ADDENDUM NO. 1

Date of Addendum: 4/24/14

PROJECT NAME: Rehabilitation of Pumps, Motors, Valves, Piping and Buildings at Various Facilities

PROJECT NO: WBS No. S-001000-0036-4

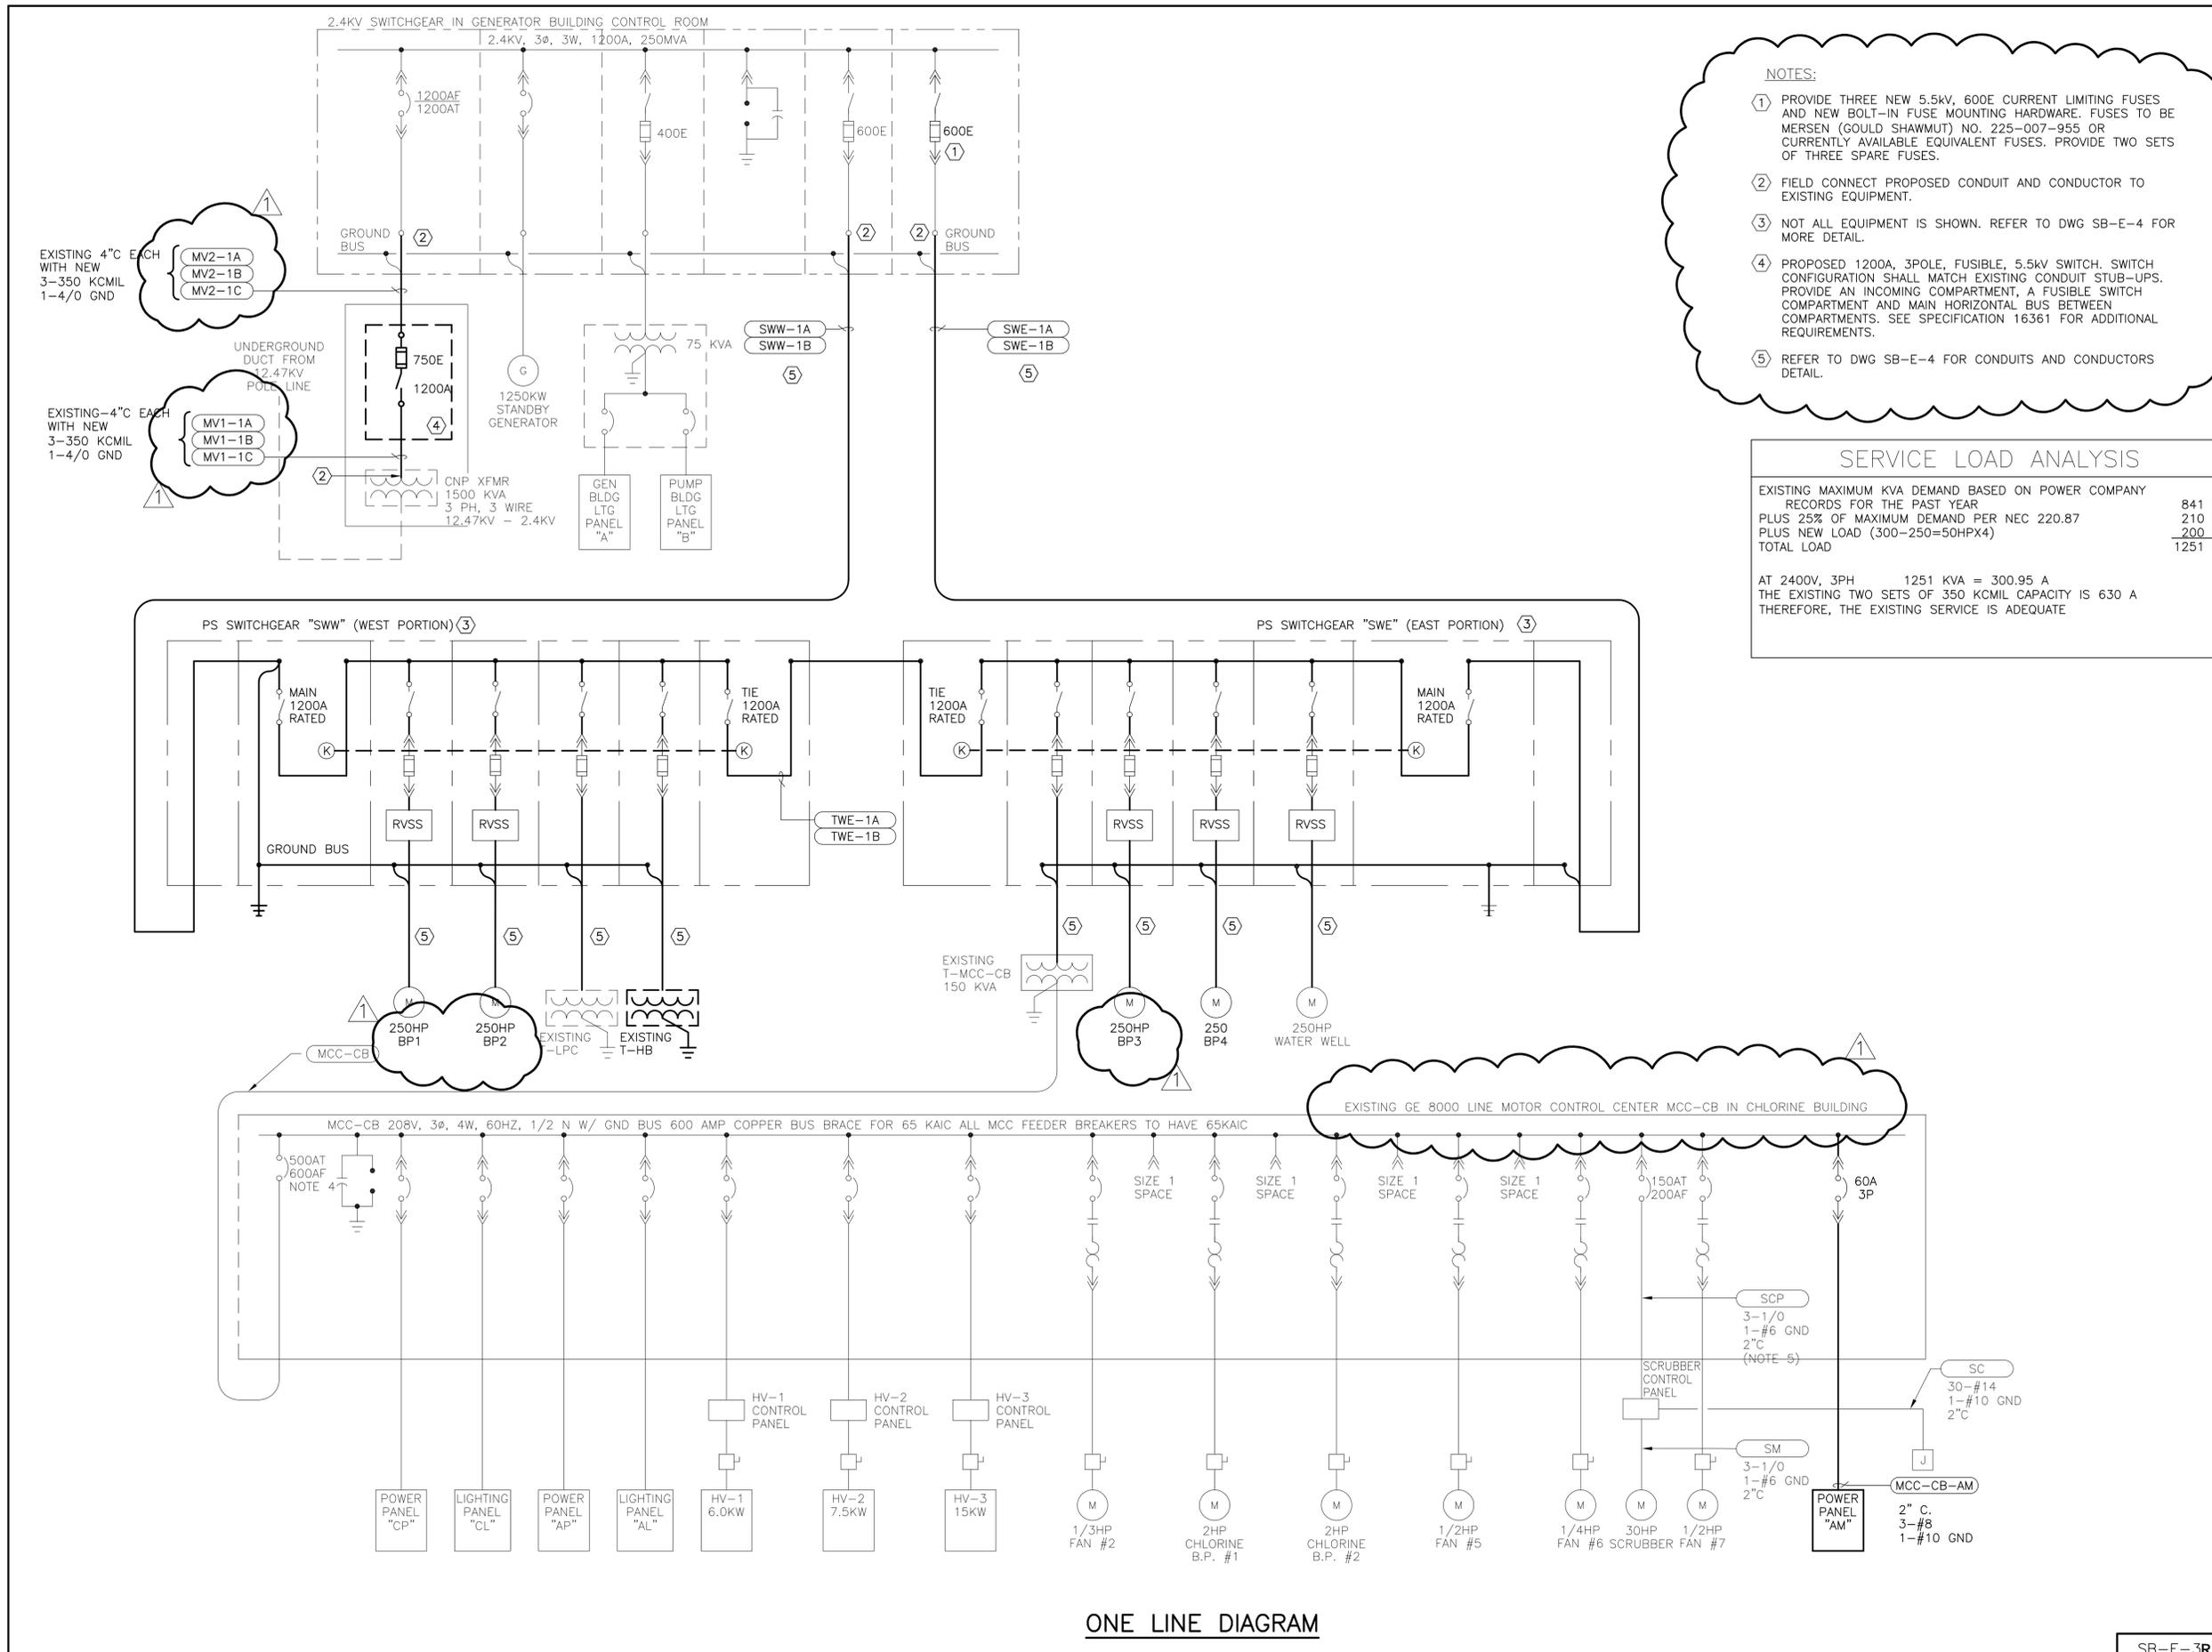
21. Delete Sheet SB-E-3, Electrical Proposed Overall One Line Diagram, and replace with revised Sheet SB-E-3R.
  22. Delete Sheet SB-E-4, Proposed PS Switchgear One Line Diagram, and replace with revised Sheet SB-E-4R.

SB-E-7R

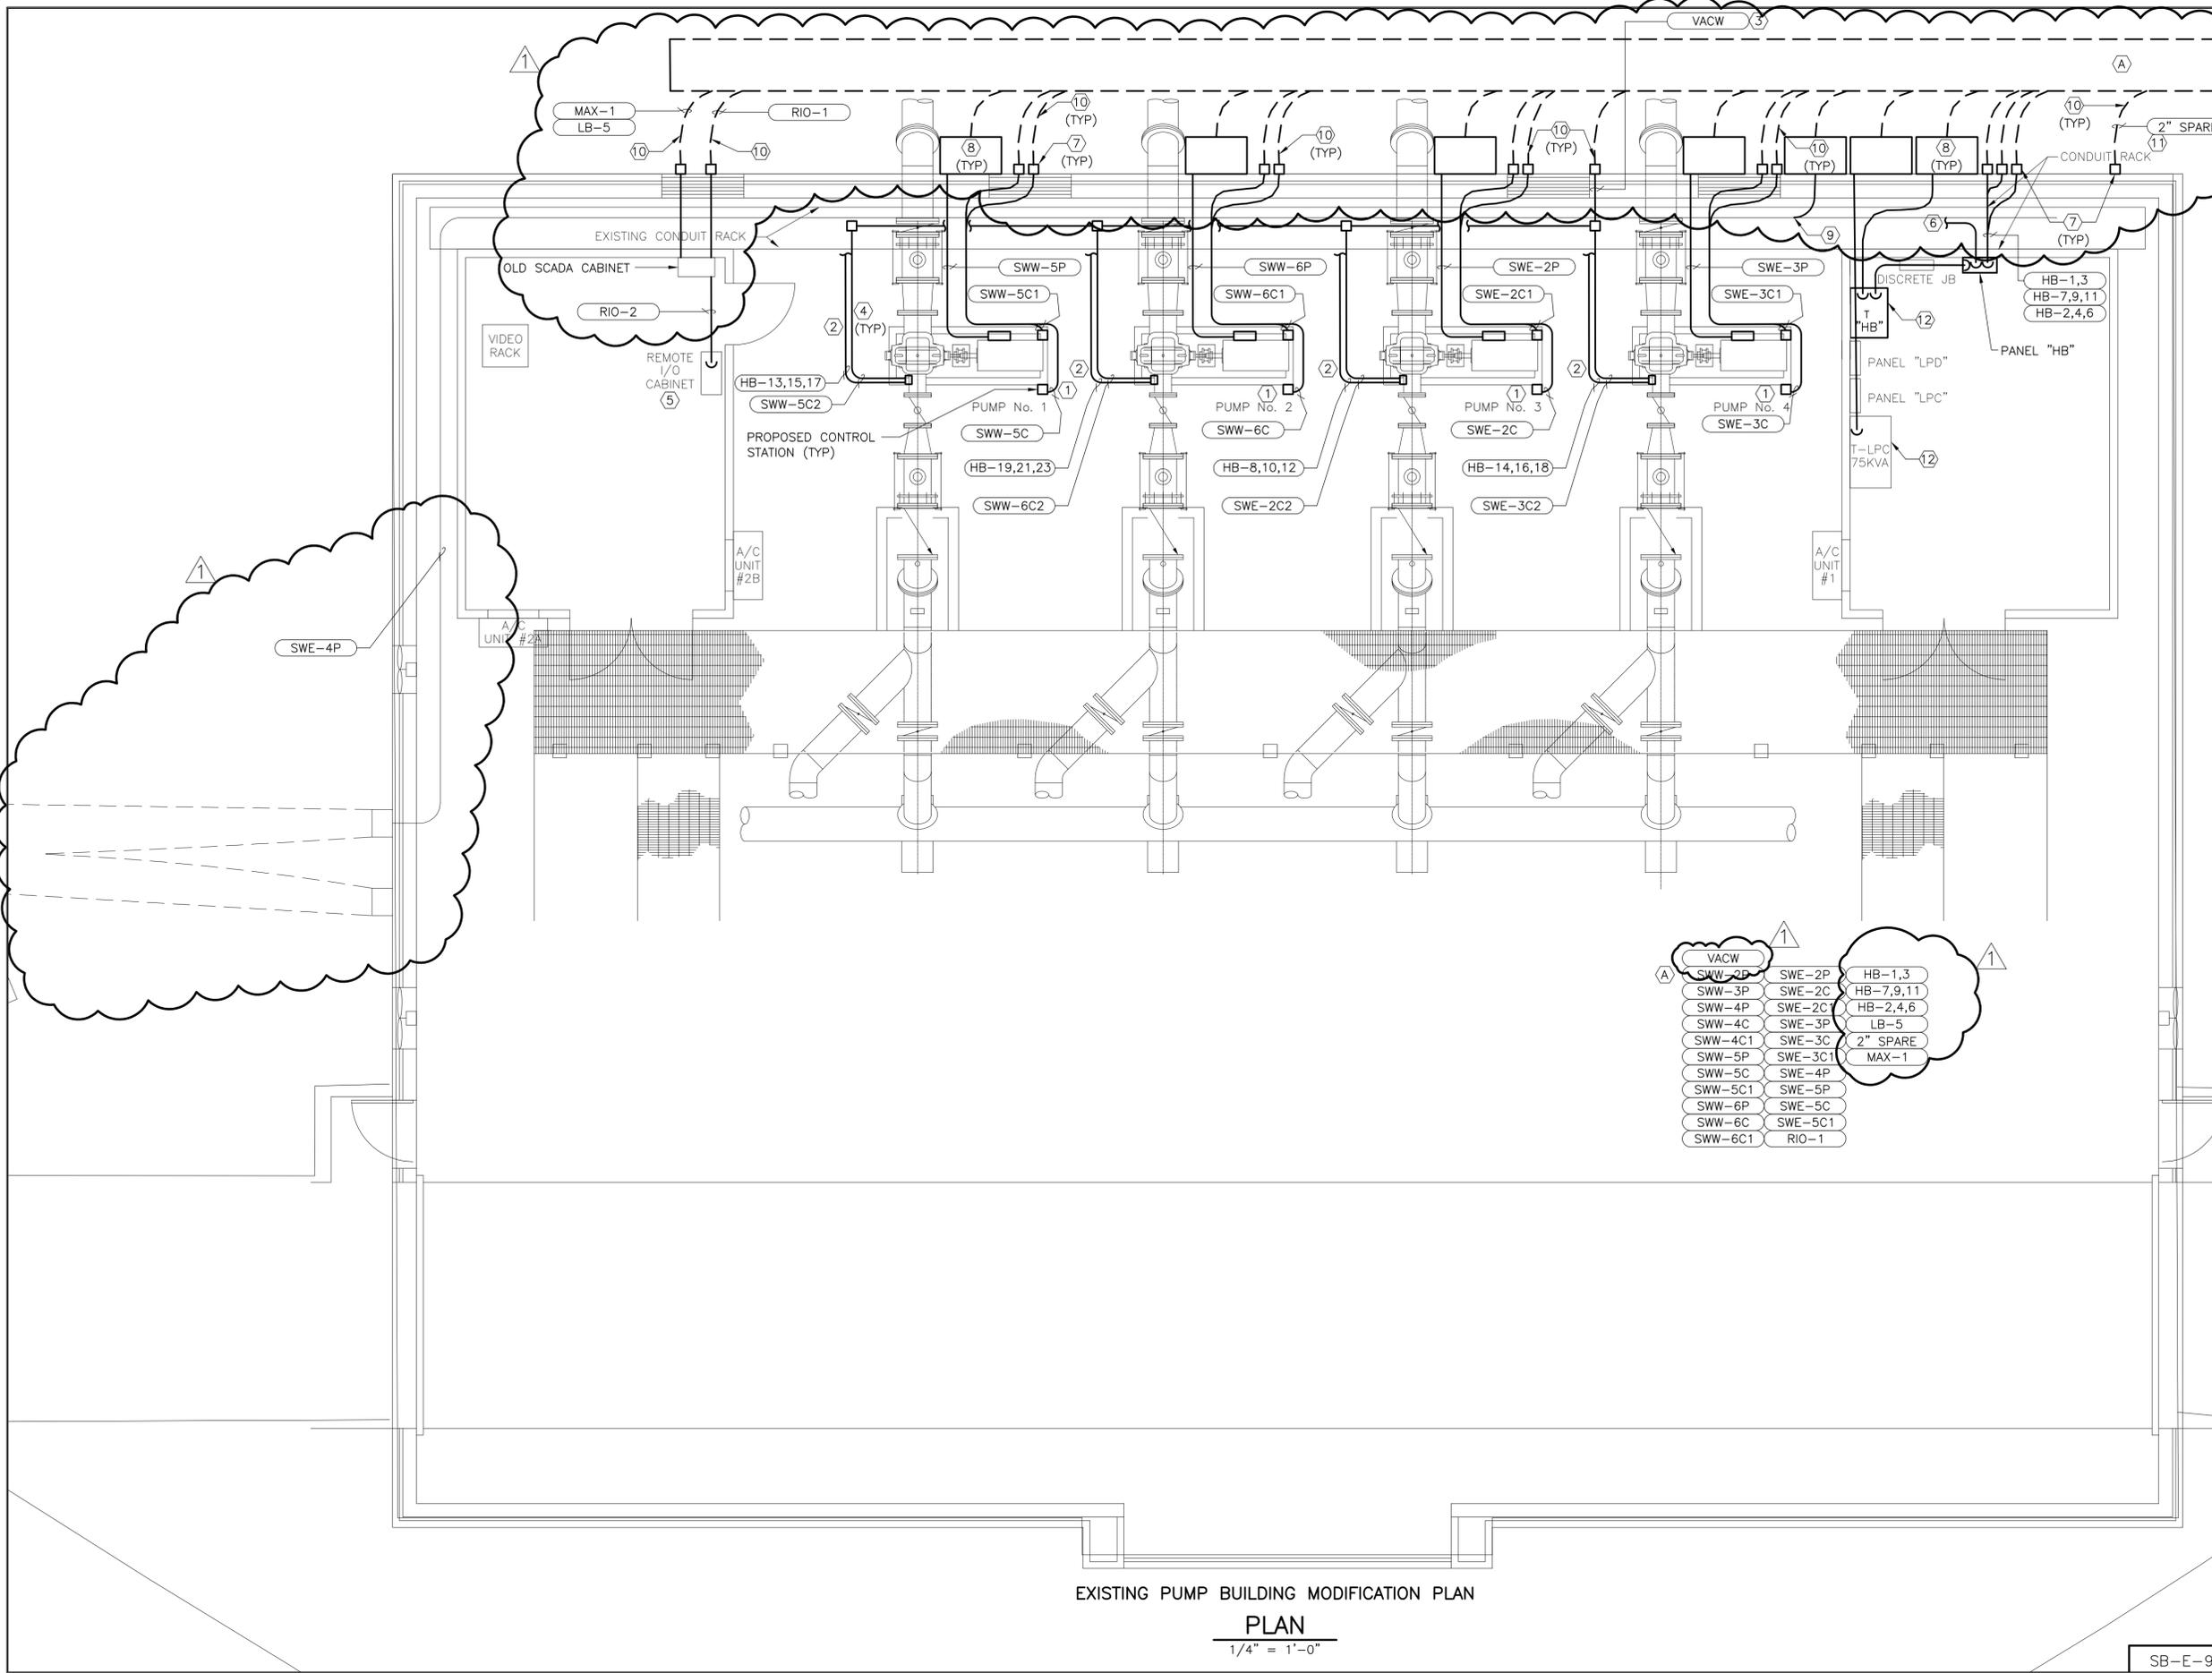
25. Delete Sheet SB-E-7, Electrical Building Power Plan, and replace with revised Sheet SB-E-7R.
  26. Sheet SB-E-8, Change Note 4 “ Relocate All Signals to Remote PLC in a 2”conduit” to read “ Verify and field route all signals from existing PLC cabinet to Remote I/O PLC in Remote I/O cabinet. Provide minimum 2 inch conduit.”

- NOTES:
- 1 PROVIDE PANIC HARDWARE FOR EACH DOOR. SEE SPECIFICATION FOR MORE DETAILS.
  - 2 30A, 3 PHASE, 316 S.S NEMA 4X ENCLOSURE.

**REHABILITATION OF PUMPS,  
 MOTORS, VALVES, PIPING &  
 BUILDINGS AT VARIOUS FACILITIES  
 PACKAGE A  
 SPRING BRANCH  
 EXISTING PUMP BUILDING  
 MODIFICATION PLAN**

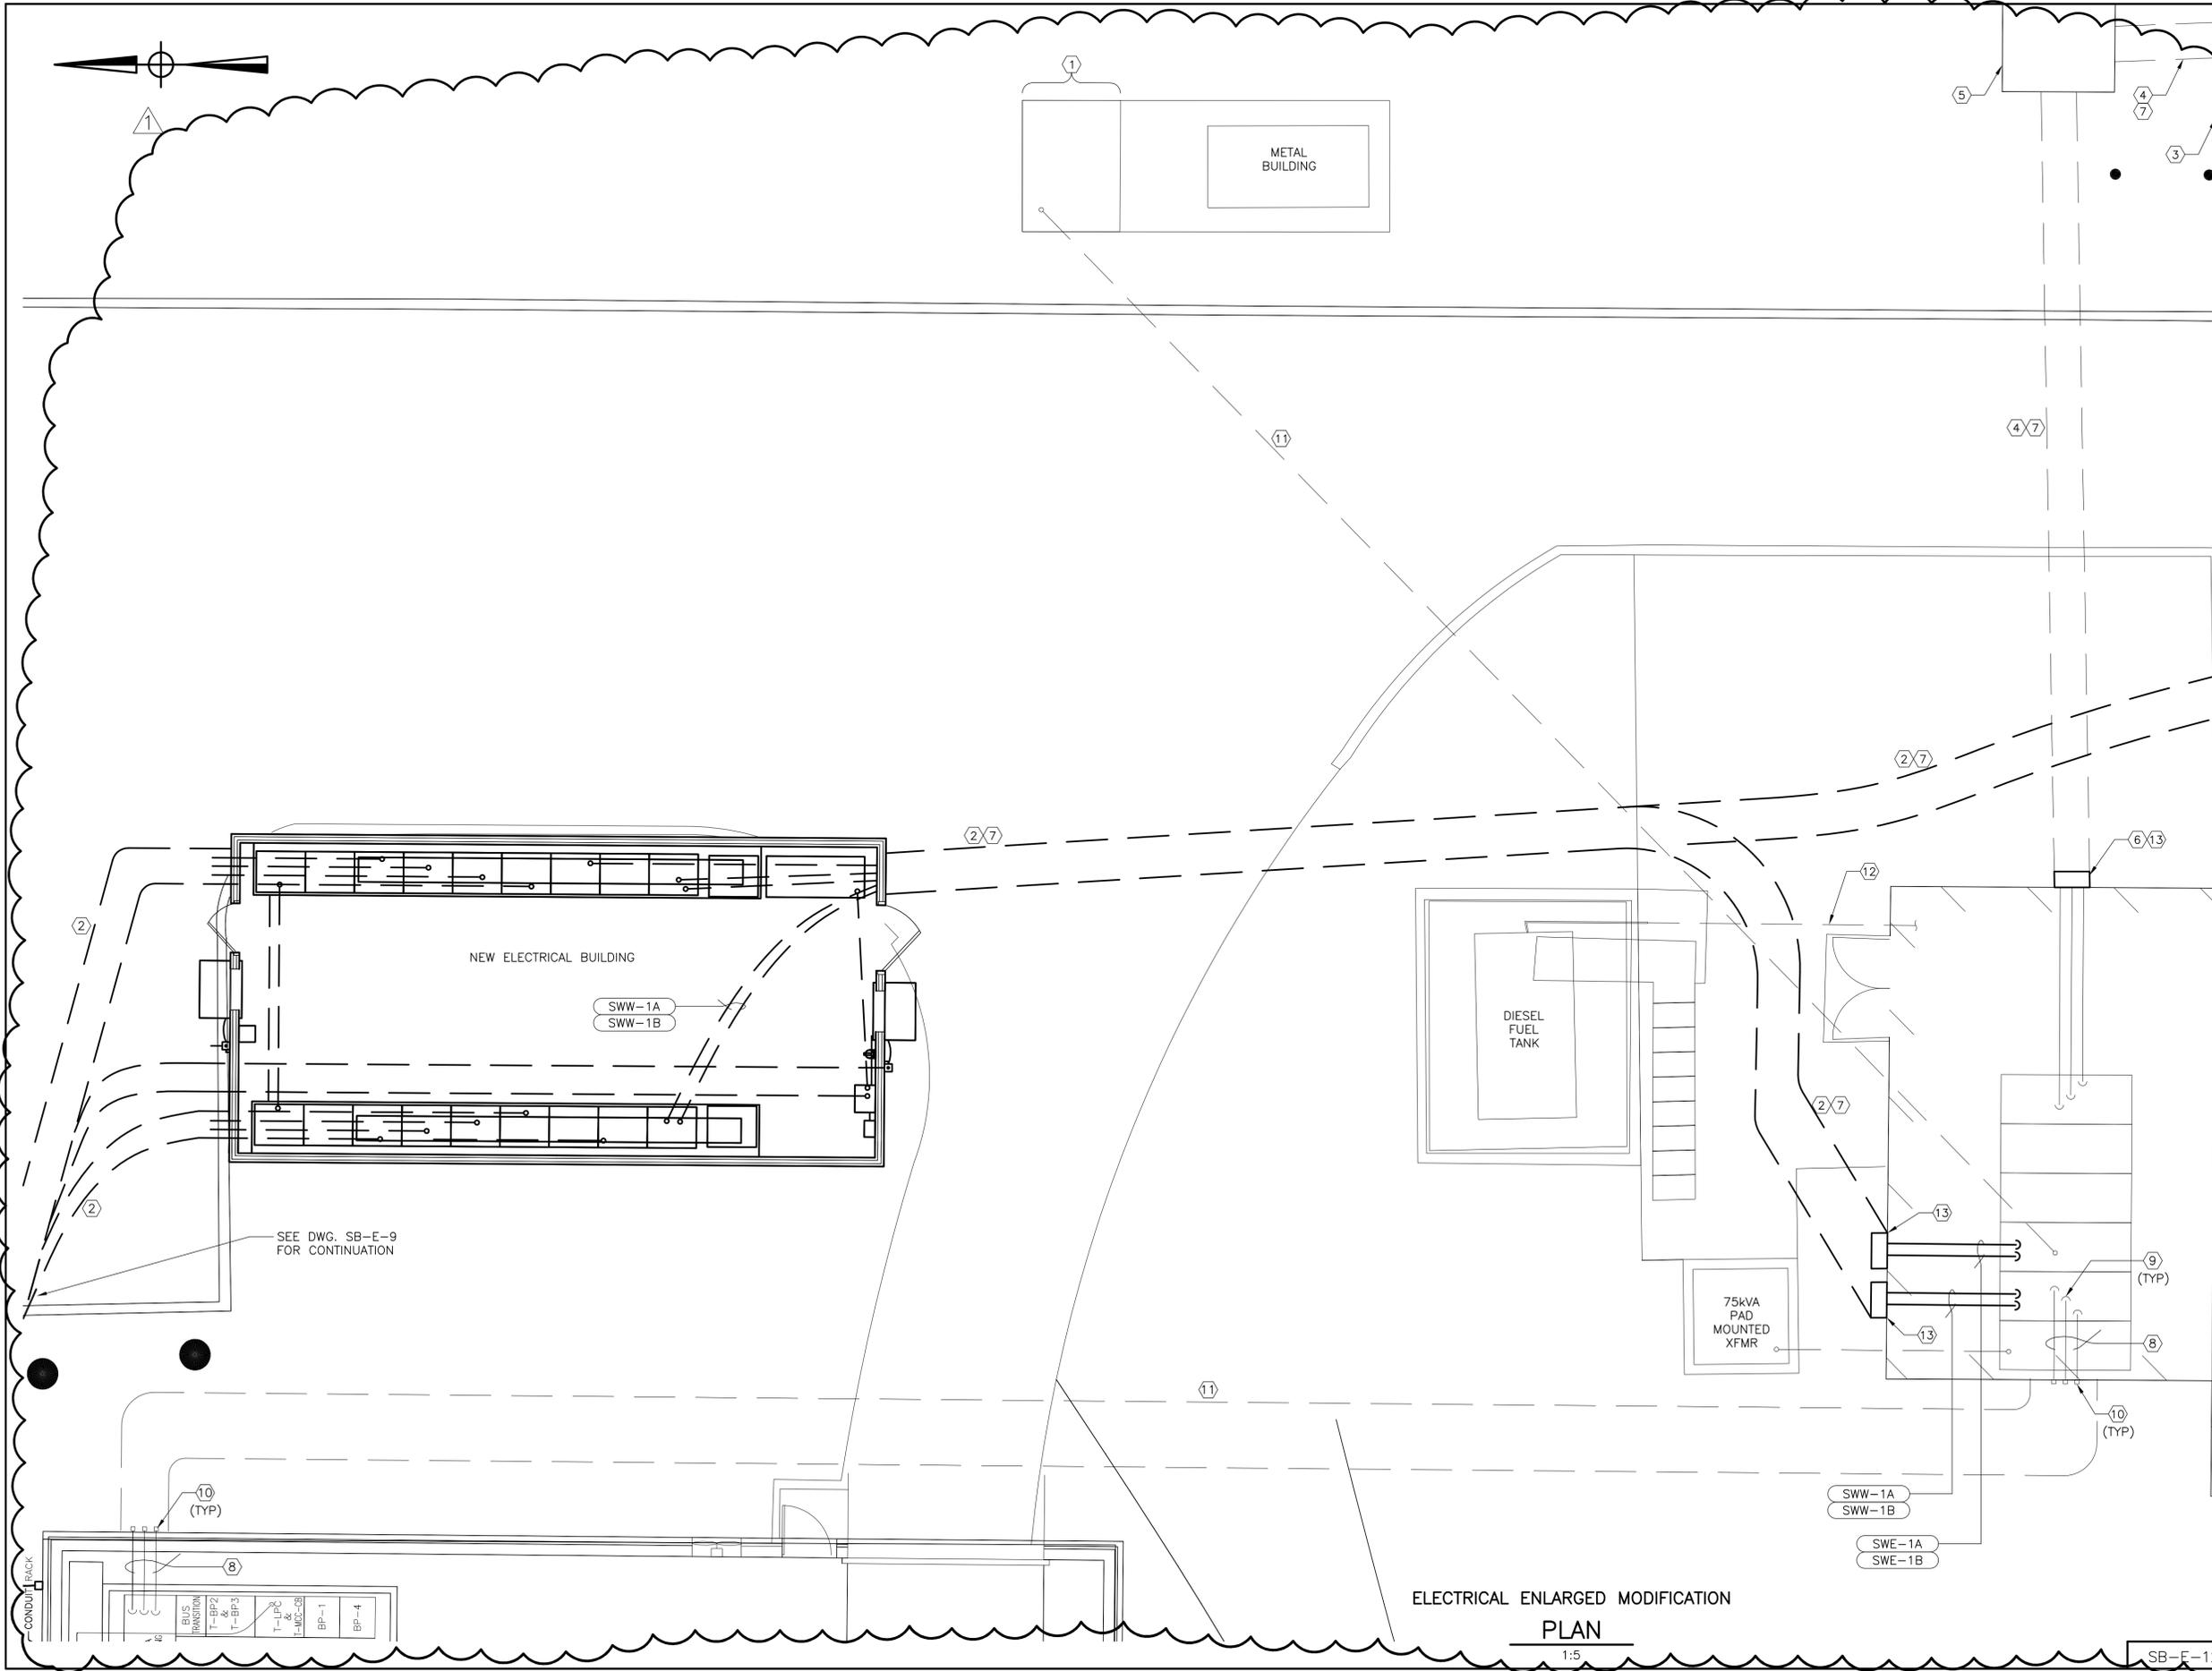
27. Delete Sheet SB-E-9, Existing Pump Building Modification Plan, and replace with revised Sheet SB-E-9R.
  28. Delete Sheet SB-E-12, Electrical Control Schematics Sheet 1 of 2, and replace with revised Sheet SB-E-12R, Electrical Enlarged Modifications Plan.
